***Bow Concord I-93 Improvements
T-A000(018)
13742***

Town of Bow

June 7, 2019

Bow Comments / Concerns

1a. NHDOT Modeling has inaccurate assumptions

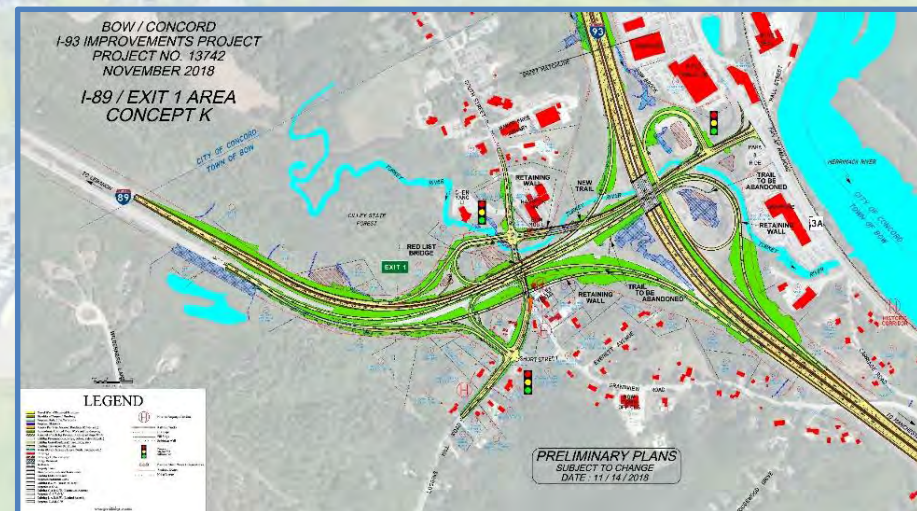
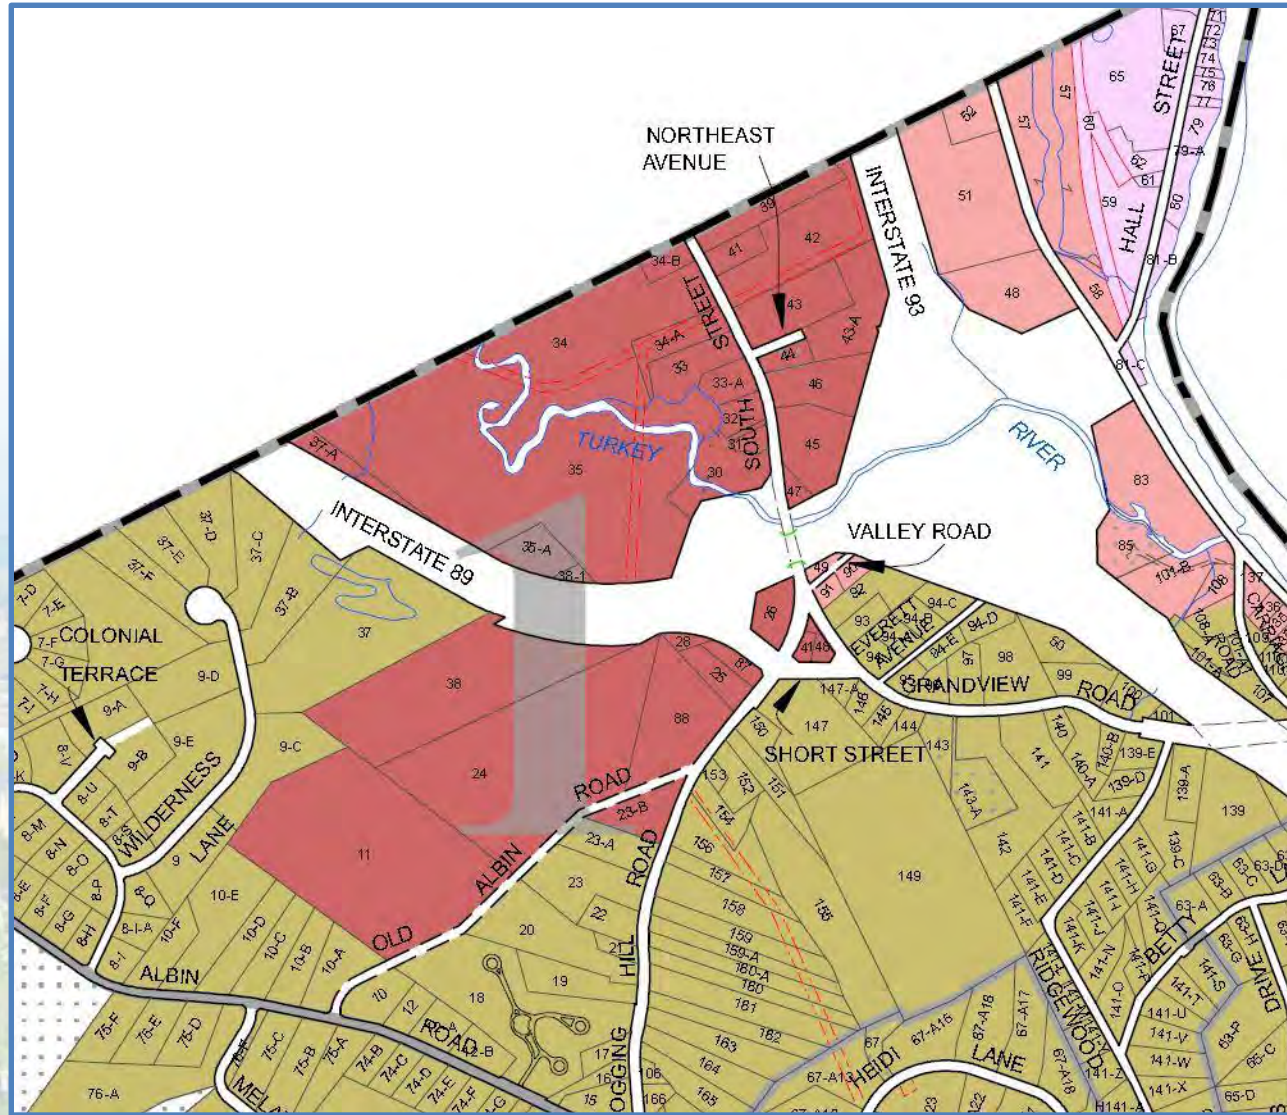
- Central NH Traffic Model and the Project Microsimulation Traffic Model developed in 2014.
- In 2017, Town of Bow approved zoning changes near I-89 Exit 1.
- Re-zoning allows for mixed use including multi-family residential and commercial/retail.
- Traffic Analysis conducted to determine potential impact re-zoning would have on the Preferred Alternative.

- Preferred Alternative is valid and achieves project goals.
- South St/Logging Hill Road would be re-evaluated during Final Design.
- All Bridges over South Street & Logging Hill Road would be constructed to accommodate future potential widening.

1b. NHDOT Modeling has inaccurate assumptions

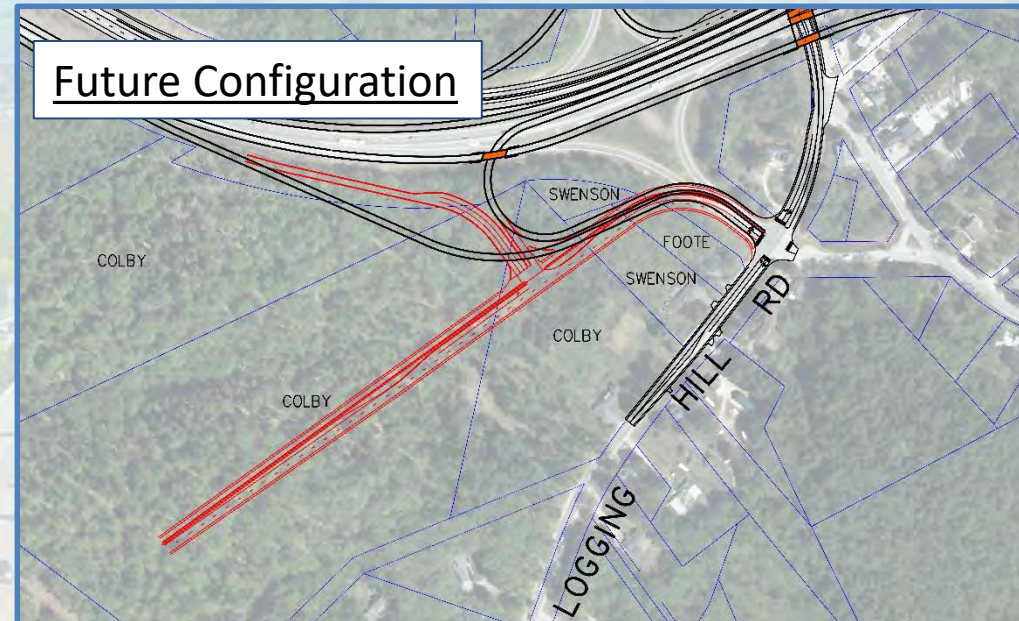
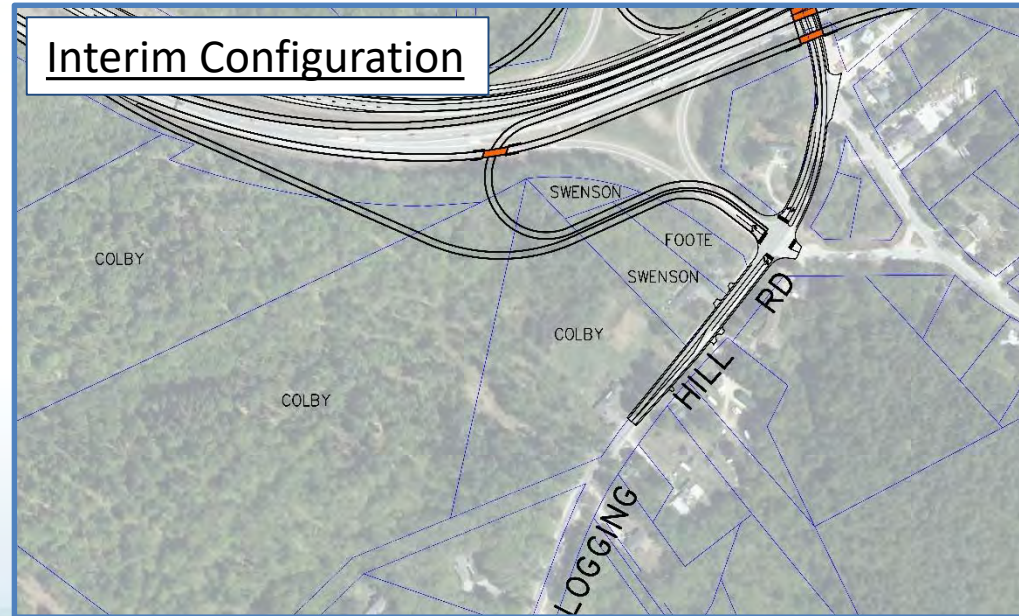
- Concept K Modified.
- Retains Exit 1 access to South Street and Logging Hill Road.
- Accommodates future connection to undeveloped land adjacent to Logging Hill Road.
- Additional property impacts, including Historic Property.

Path A:

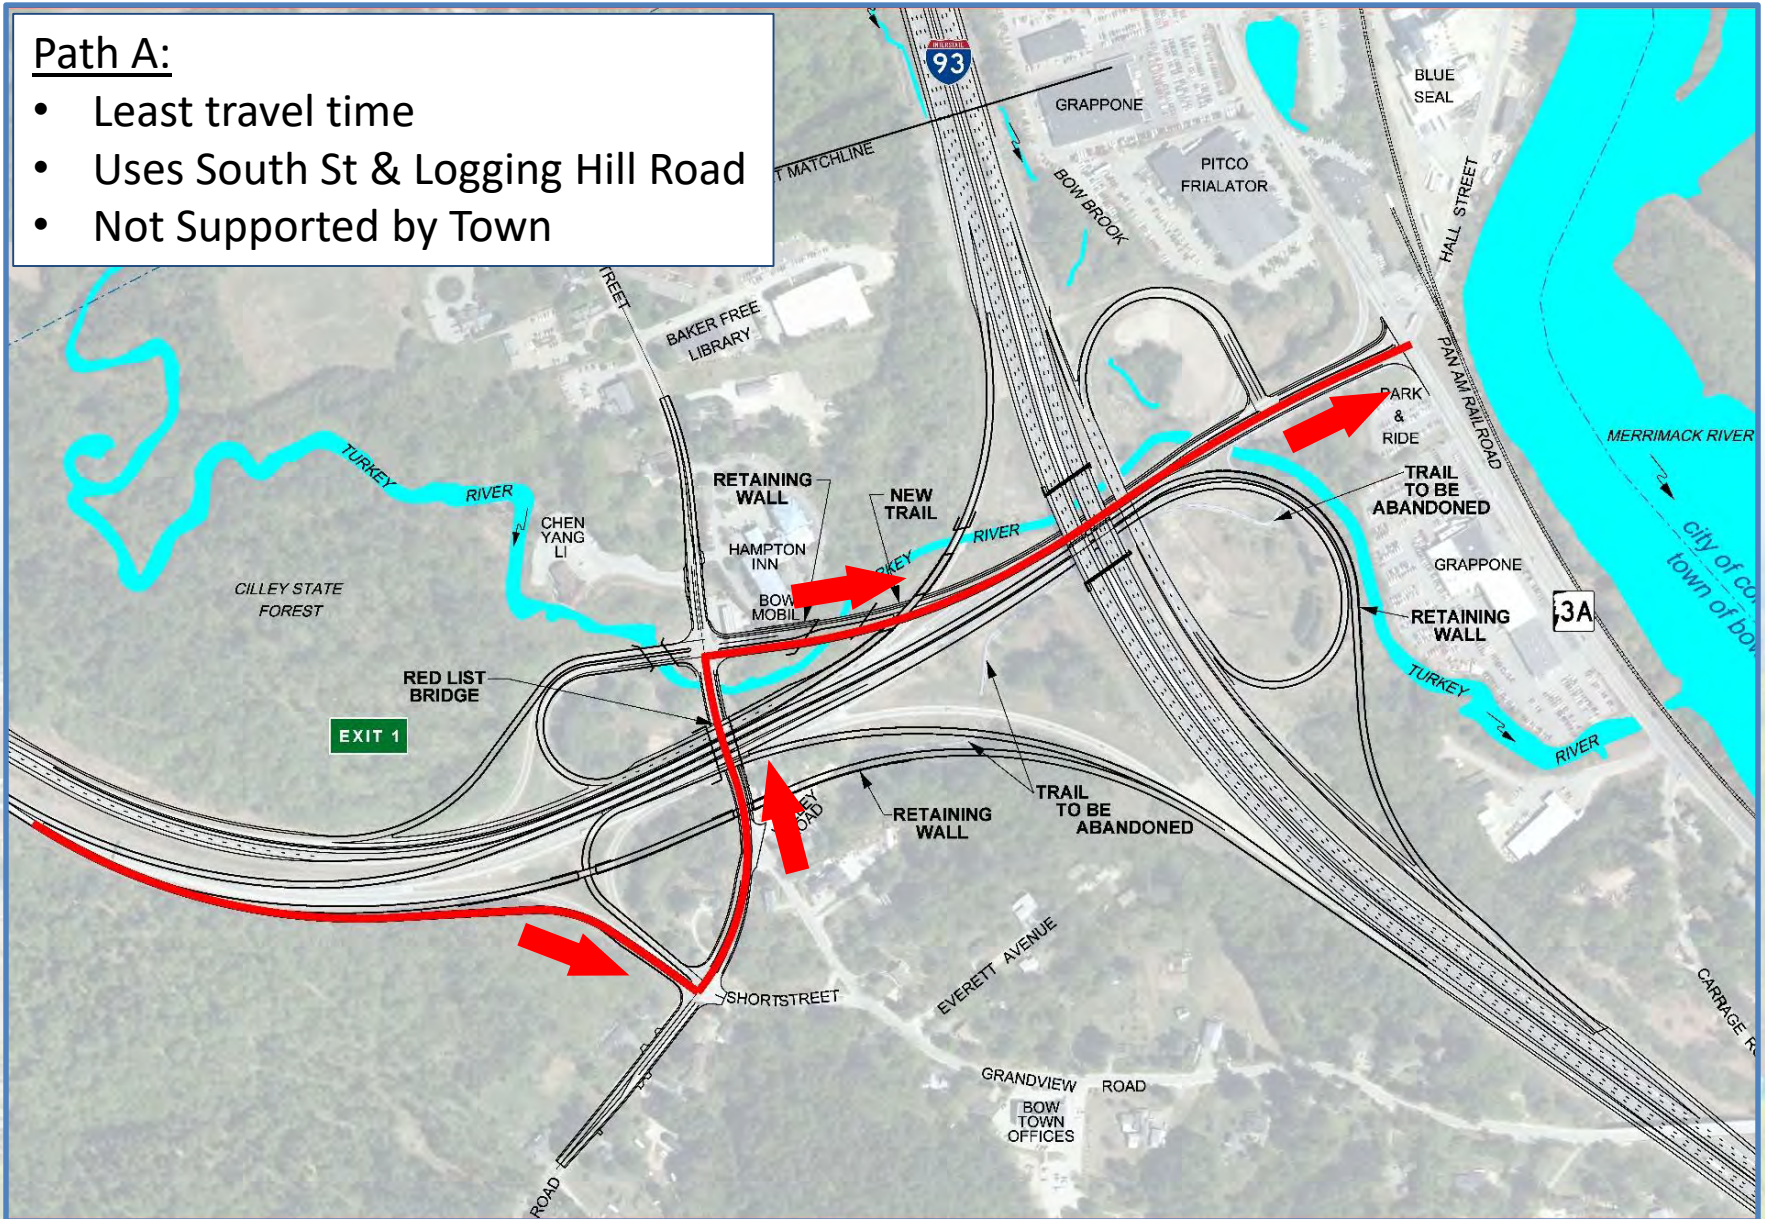
2. NHDOT Modeling failed to Consider Impact on Business Corridor

- Least travel time
- Uses South St & Logging Hill Road
- Not Supported by Town

Path B:

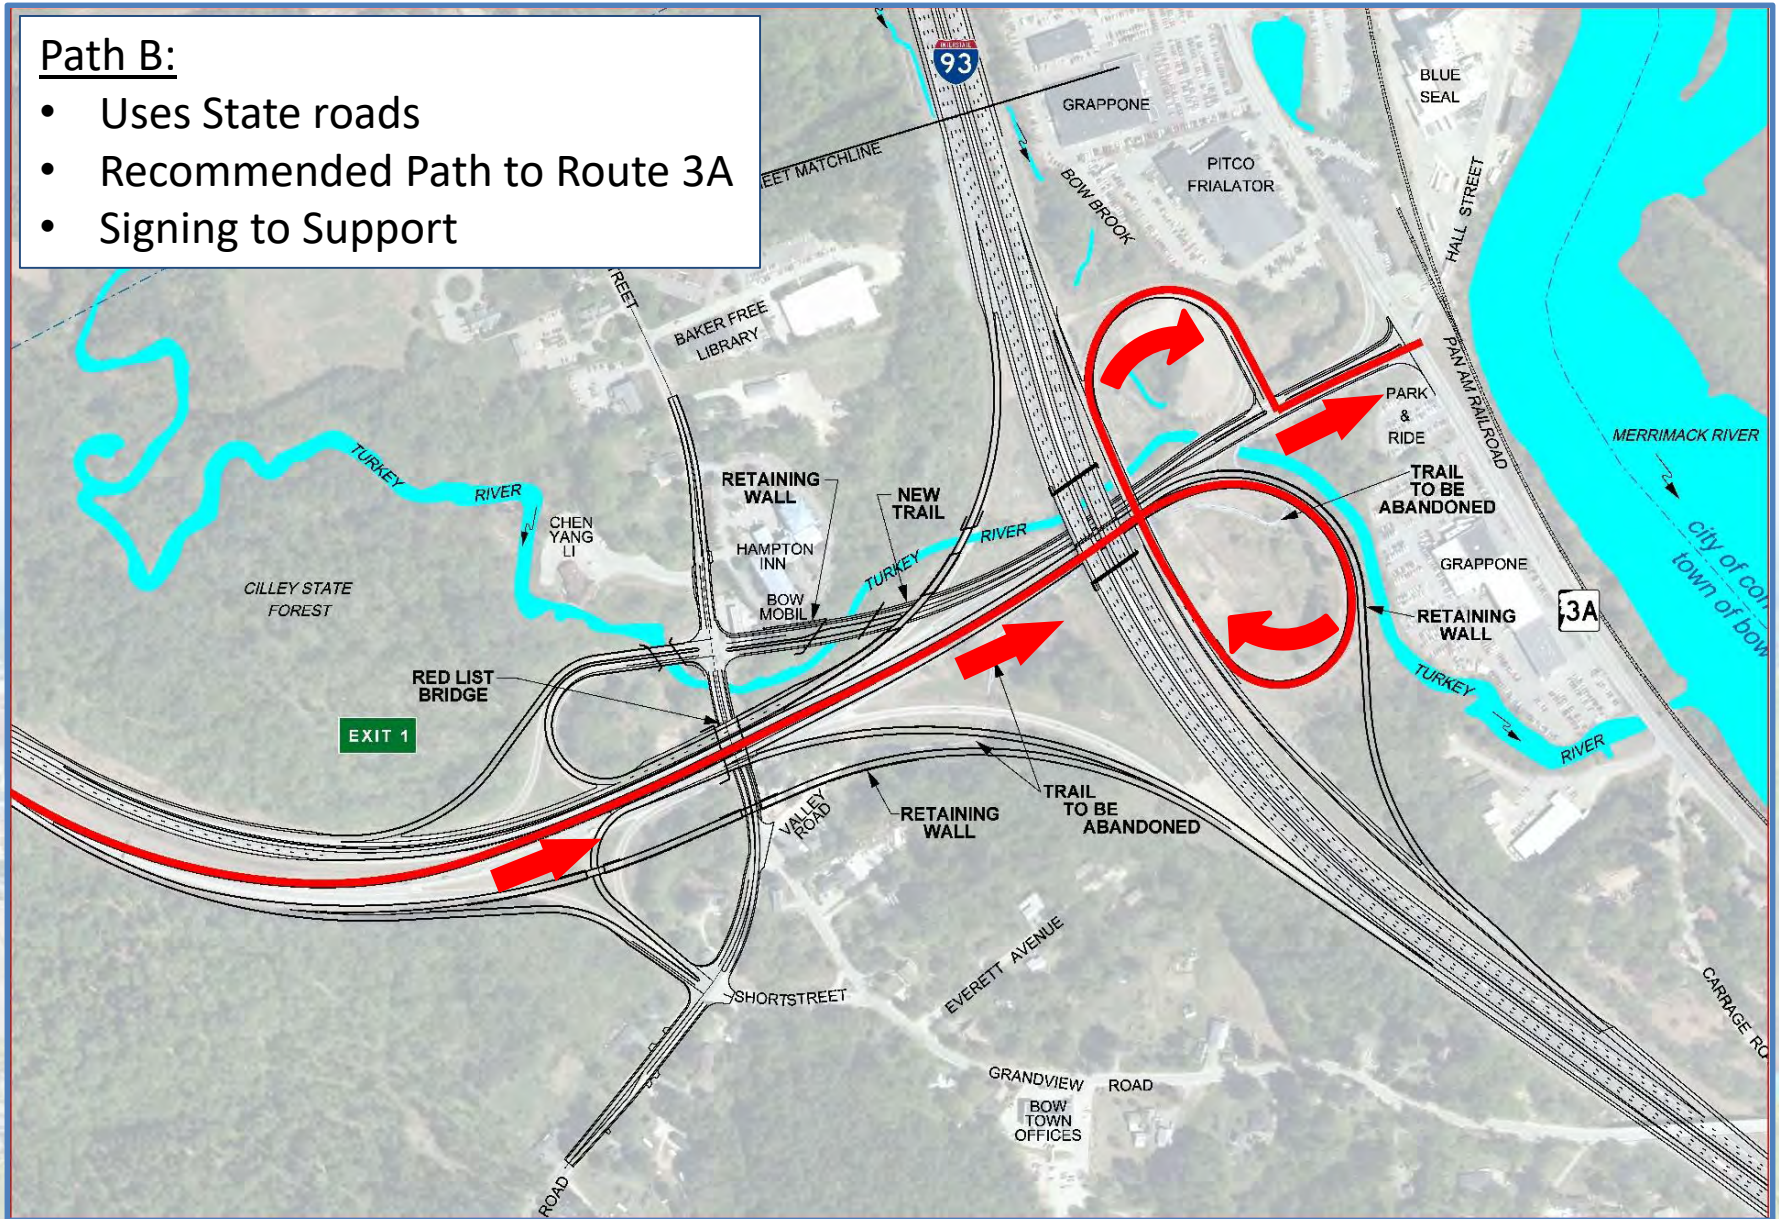
- Uses State roads
- Recommended Path to Route 3A
- Signing to Support

Concept K2:

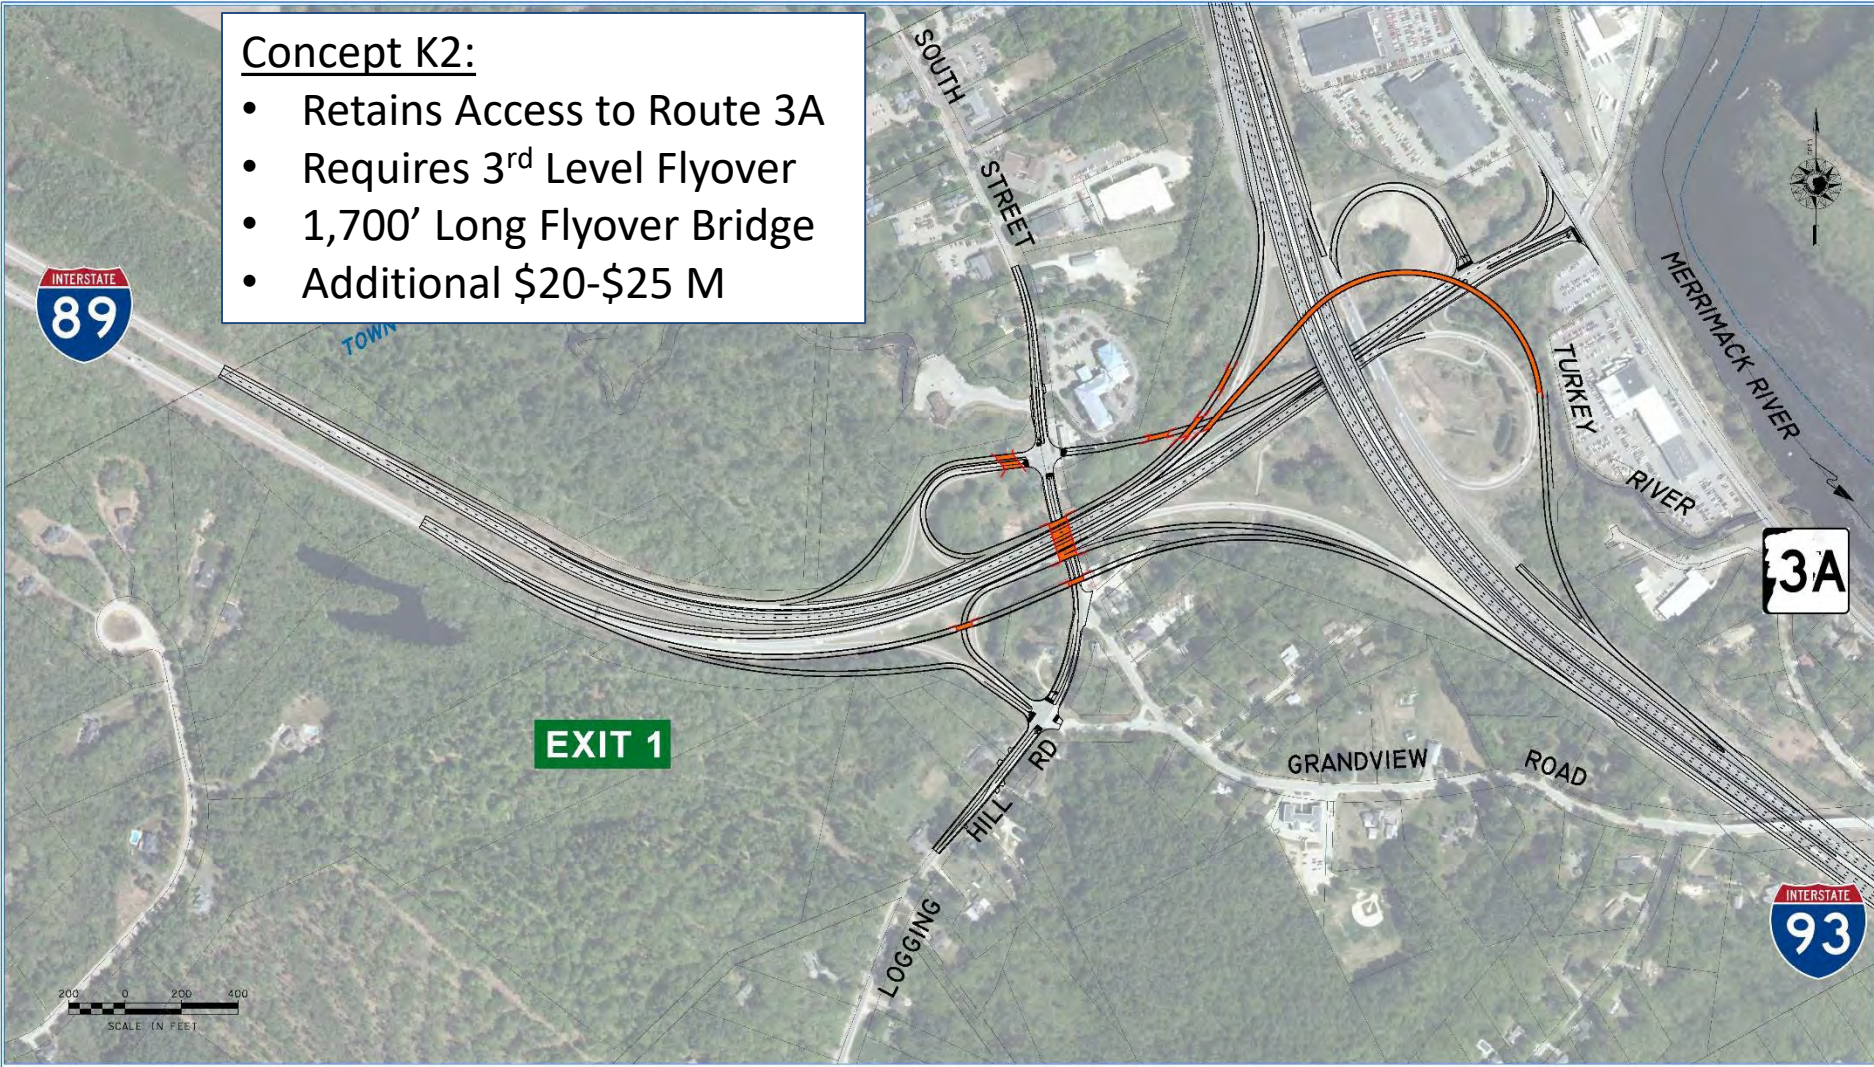
- Retains Access to Route 3A
- Requires 3rd Level Flyover
- 1,700' Long Flyover Bridge
- Additional \$20-\$25 M

4. Photosimulations Needed to Evaluate Impact

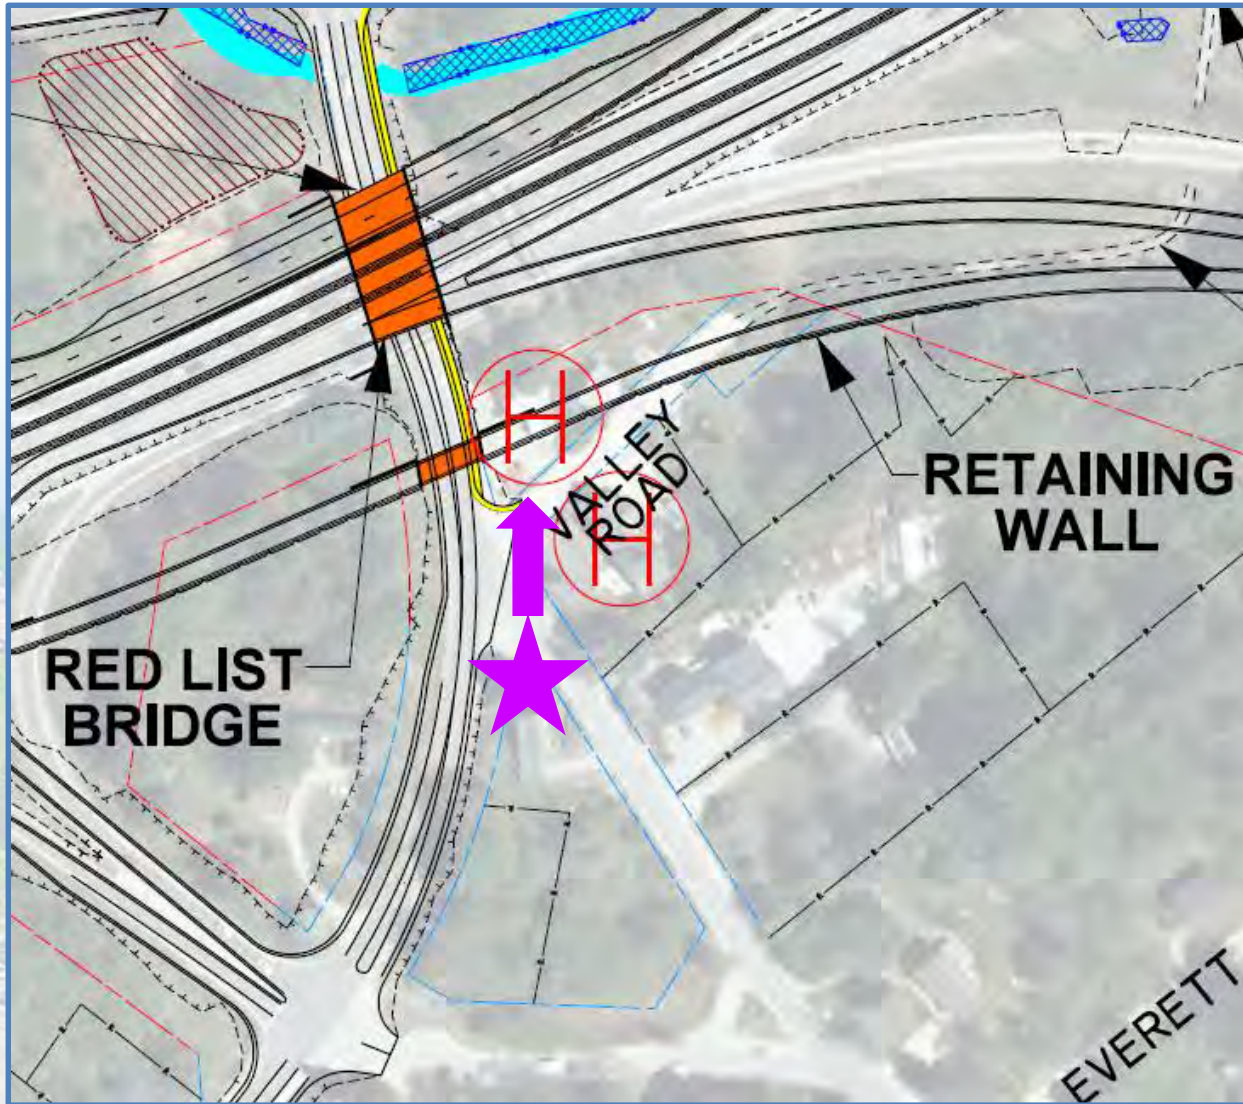
Existing View from Grandview Road

Rendered View from Grandview Road
